Smart Touch Display Board

Installing the Display Board

Display Board with new slot cut out

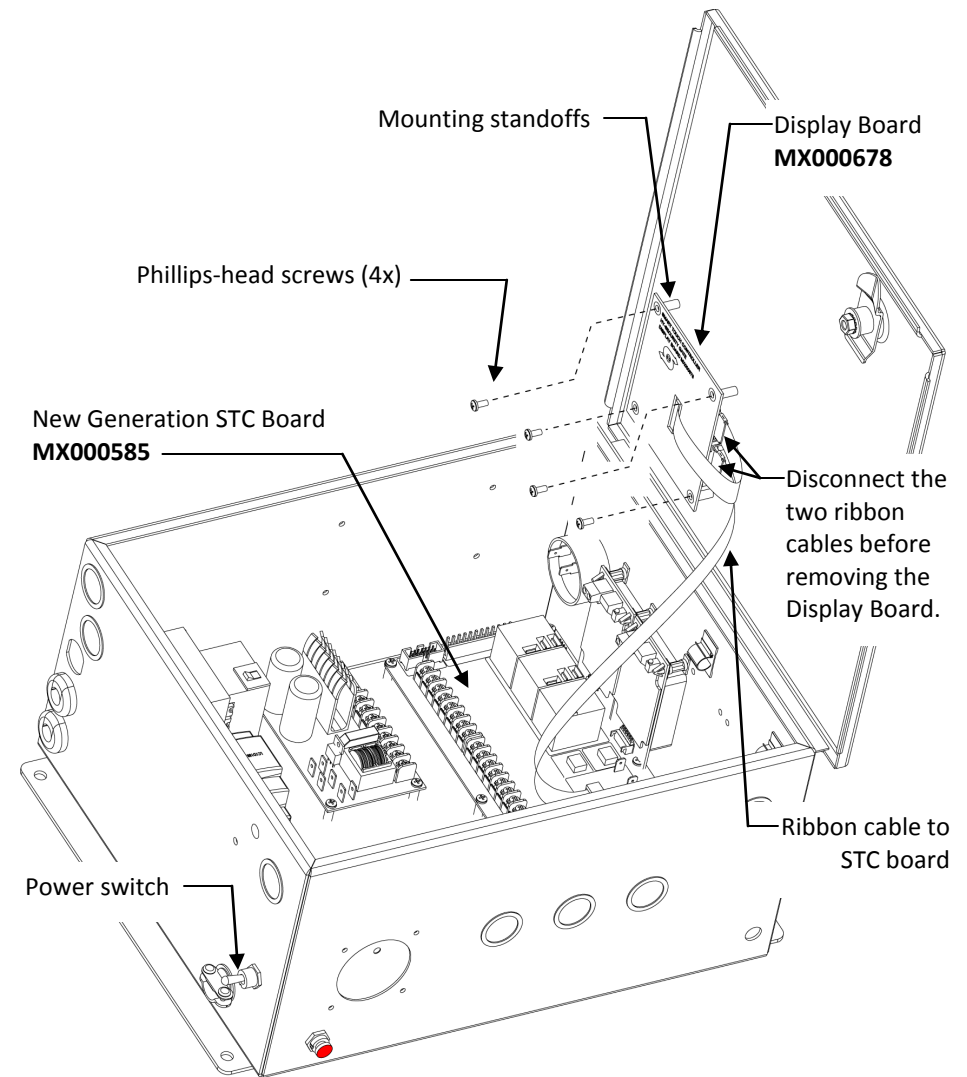
A slot in the middle of the display board allows free passage of the keypad's ribbon cable and makes for an easier installation. It eliminates the necessity to bend the ribbon cable around two tight corners and reduces wear and chaffing against the lid of the Control Box.
